Planning Commission Meeting

June 9, 2026 6:00 PM

4.1. 3264 Springhaven Drive Site Plan Revision Request

DATE: June 1, 2026
TO: Adrienne Senter
FROM: Lynn Patterson
RE: **Site Plan Review – Stillwood Farms Revised**

SITE EXHIBIT
FOR
STILLWOOD FARM
LAND LOT 98, 14TH DISTRICT
THE CITY OF HAPEVILLE, FULTON COUNTY, GA

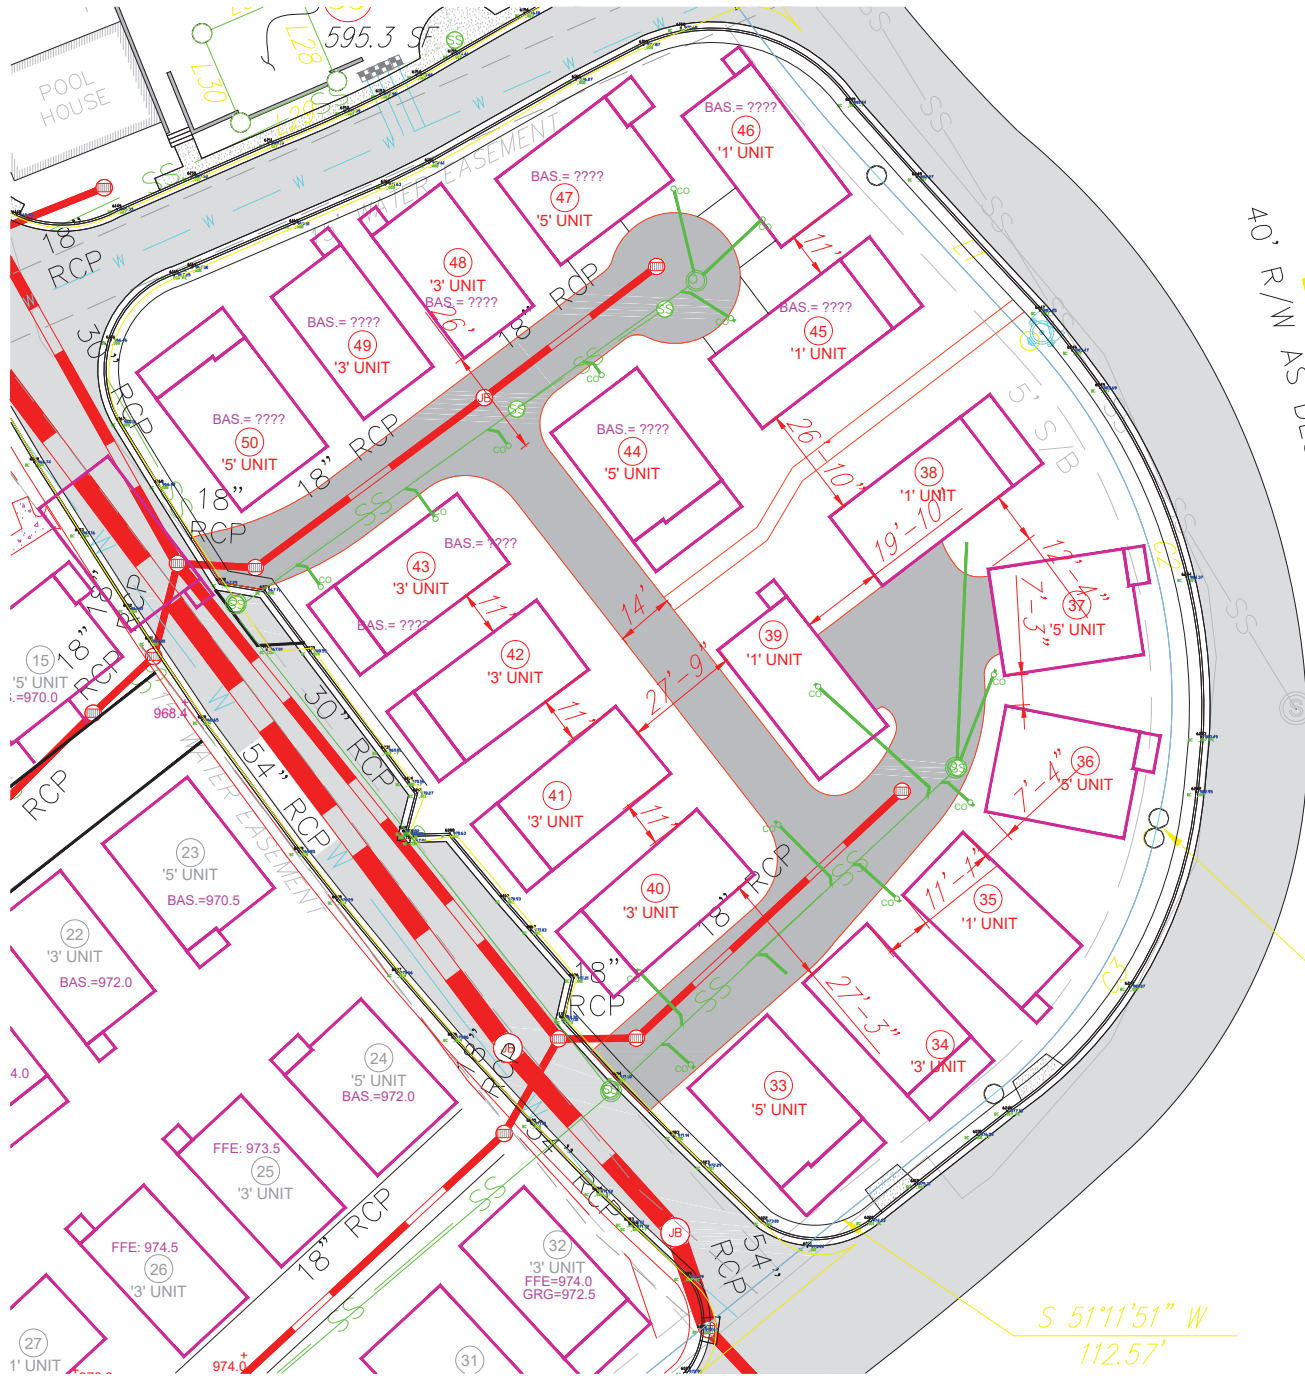
The City of Hapeville has received a revised site plan application from Stillwood Development for a planned unit development to be located on 4.17 acres. The original site included 58 alley-loaded single family units fronting on the adjoining streets or common greenways, a pool, and dedicated greenspace. The proposed revisions in Phase V and Phase VI removes two units and adds a connecting drive between the two internal driveways.

2 parking spaces per dwelling unit are required for development. Parking spaces are either provided in attached garages or parking pads adjacent to the dwellings. Five (5) additional parking spaces have been provided near the common area/mail, 4 parallel parking spaces have been provided along the internal driveway and 20 parallel parking spaces have been provided along Springhaven.

Should Fire Marshal find the new design satisfactory with regard to Life / Safety Codes, Design Review Committee and City Staff recommend approval of the revised site plan.

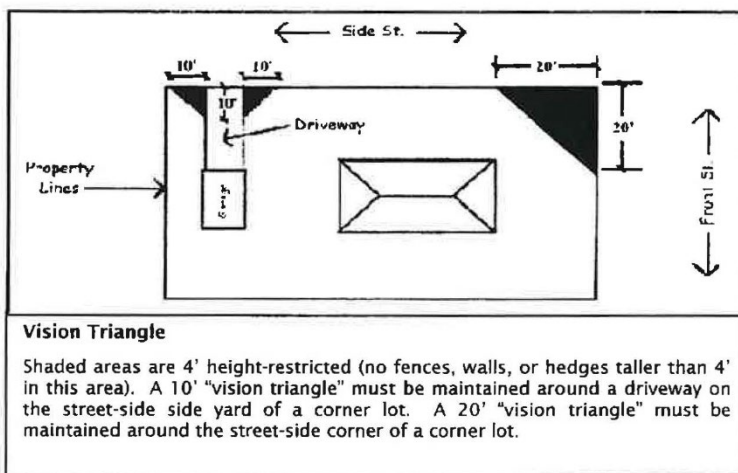
There is an existing chain link fence. Chain link is not permitted in areas visible from the right of way. Should a fence be desired, it must adhere to the following standard:

4) Fences and freestanding walls.
